Subject: 109A Church Street, Lidcombe
Submission to DA2023/0130 – Demolition of existing buildings and construction and operation of an organic waste transfer station

Project:	Office:
Project No:	Assisted by:
Client:	Approved by:
Date:	Status:
Subject:	109A Church Street, Lidcombe - Proposed Organic Waste Transfer Station Transport Engineering Peer Review

Figure 1: E Boloutis Traffic Report Extracts – Ground Floor with Swept Path Test for 20.0m Articulated Vehicle

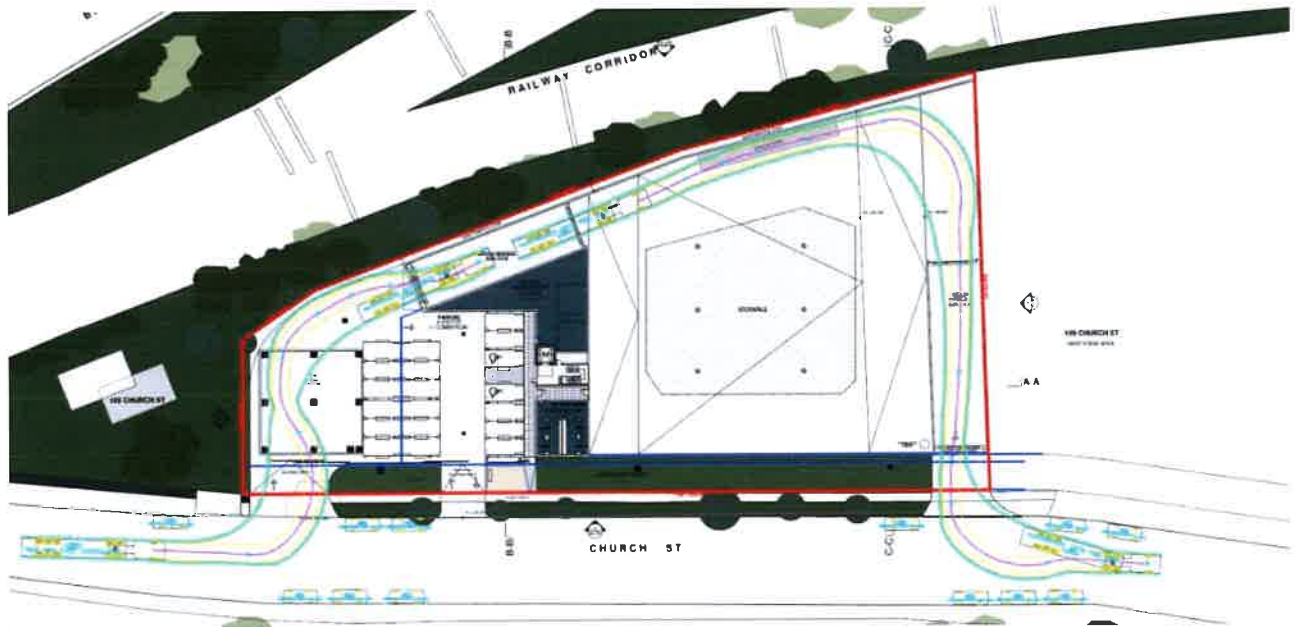
An extract from the TIA report submitted with the application showing turning paths for a 20.m articulated vehicle for the proposed development layout is provided at Figure 1. This analysis includes 20.0m articulated vehicles accessing the site from the west and (possibly) via Church Street and the Lidcombe Town Centre.

A review of the material accompanying the development application indicates that there is no qualified basis upon which the author of the Transport Impact Assessment can on a quantitative or qualitative basis determine that the estimated level of transport activity can be satisfactorily accommodated by the surround transport network.

3. The ability of required travel routes to cater for the select vehicle weights. By way of example, the Church Street bridge located to the immediate west of the site is rated with a 15tonne GVM limit which is unlikely to cater for vehicle mass requirements associated with the proposed use. The application material is absent of detail required to determine the mass limit requirements of commercial vehicles and activities likely to be associated with the proposed use of the land,

4. The ability of required travel routes to cater for the nominated vehicle types and sizes, particularly the linking street network to the west which includes intersection controls (roundabouts) which may not be capable of accommodating the turning requirements of larger vehicle types,

Figure 2.5 – The Proposed Q15: Roof Plan and OMS stack location

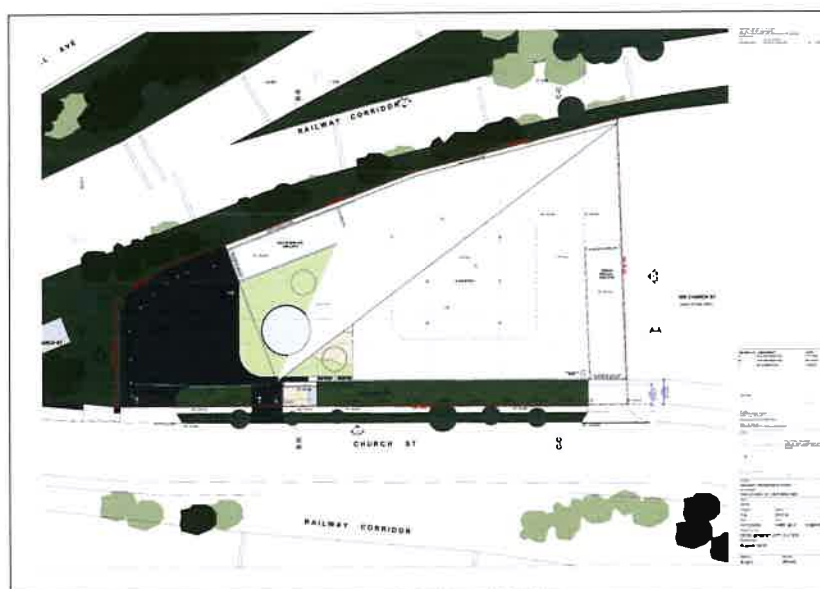
Figure 2.5 of the odour assessment report, shown below, is labelled *The Proposed OTS: Roof Plan and OMS stack location* (replicated below for ease of reference). However, as far as can be ascertained, the location of the OMS stack is not identified on this figure.

Isopleths showing the predicted concentrations for each scenario are shown in Figure 6-1 to Figure 6-3 of the odour assessment report. An image of each is shown below in Figure 2, Figure 3 and Figure 4, for ease of reference.

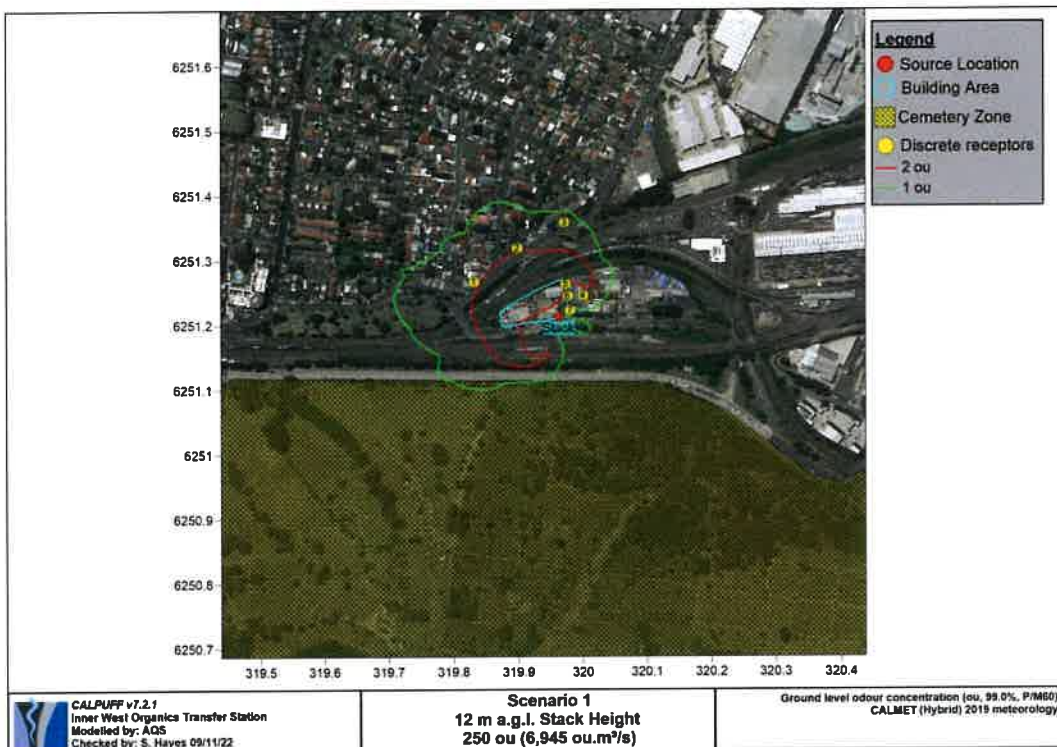
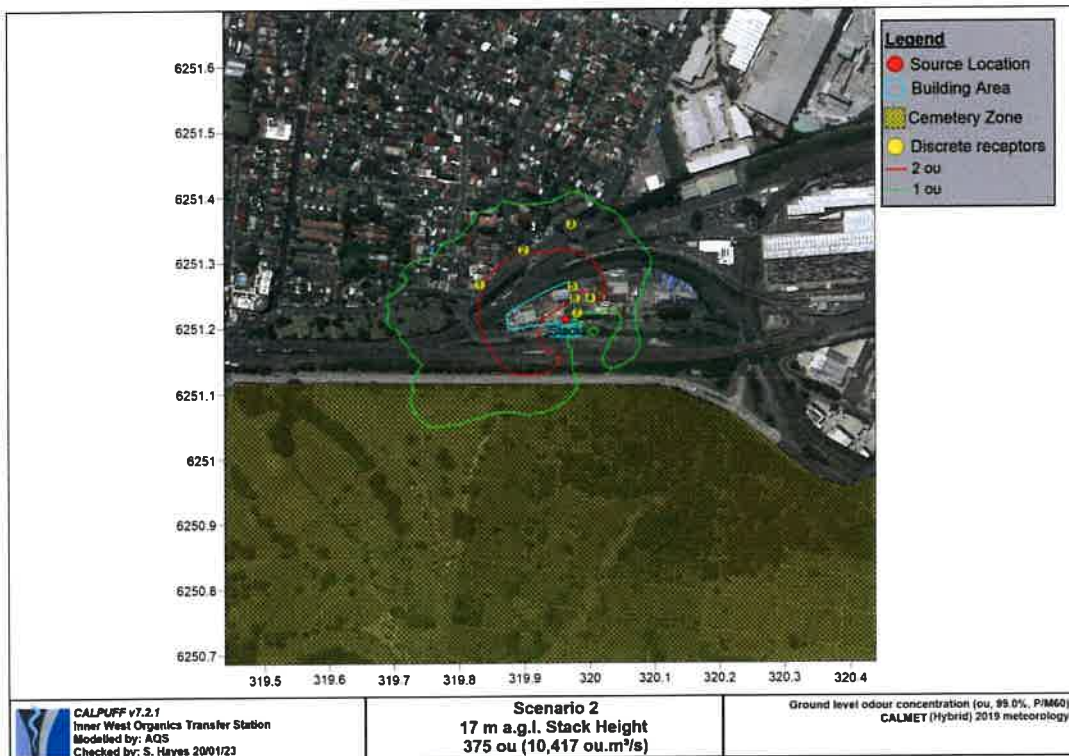
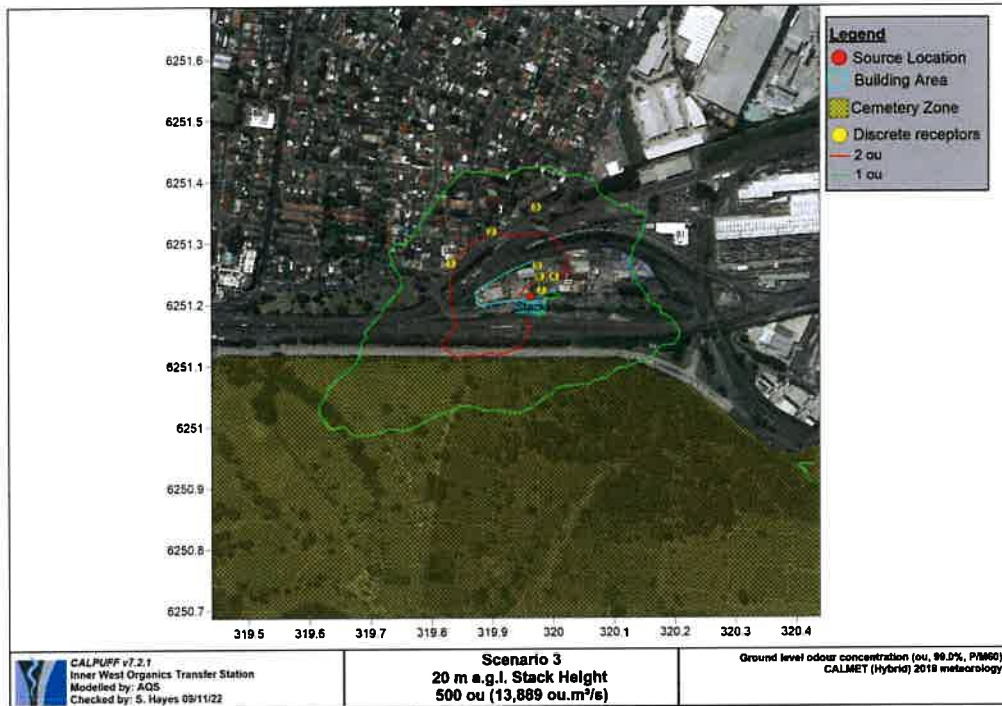
- **FINDING:**
 - The predicted odour impacts at the residences are shown to meet the relevant criteria. However, as discussed at Section 2.3.4, any change to the assumed parameters may result in exceedances.

Figure 1 Waste sites and transfer stations in Sydney

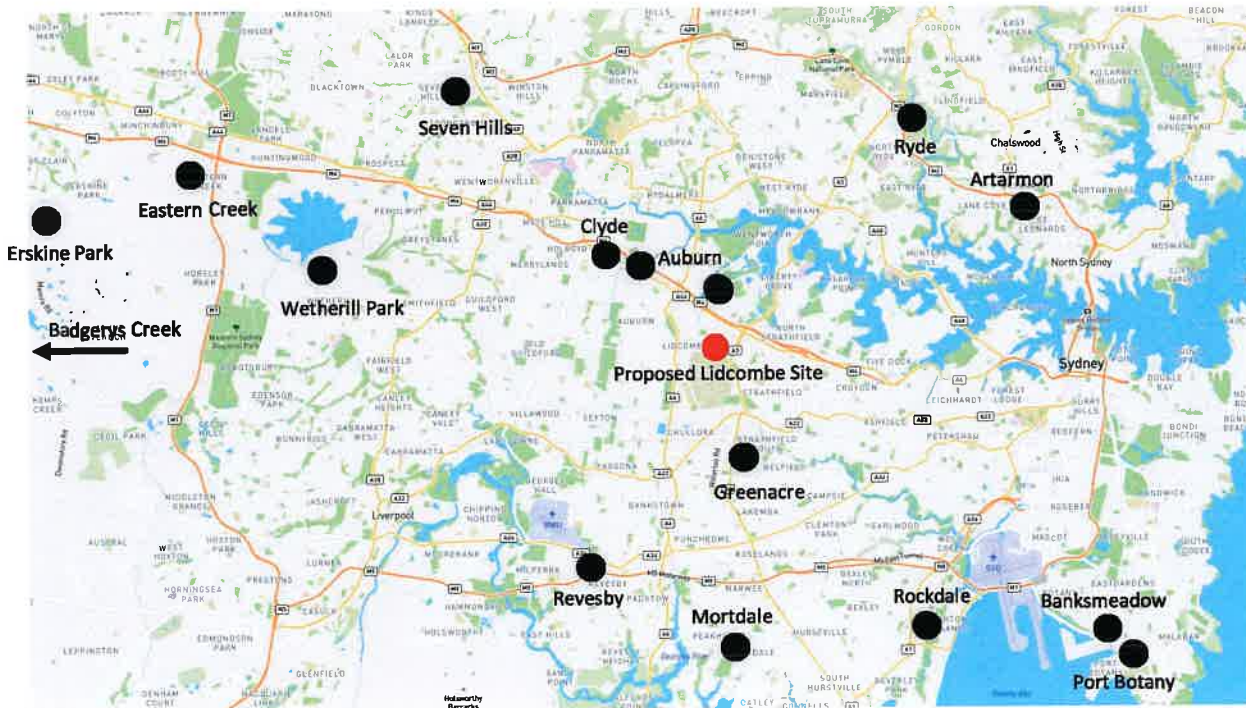
The table shows that there are 12 other sites within a half hour drive of the proposed site. Figure 1 below shows these on a map.

The maps shows that the proposed site is in the middle of an area already well-served by waste facilities that could accept organic waste.
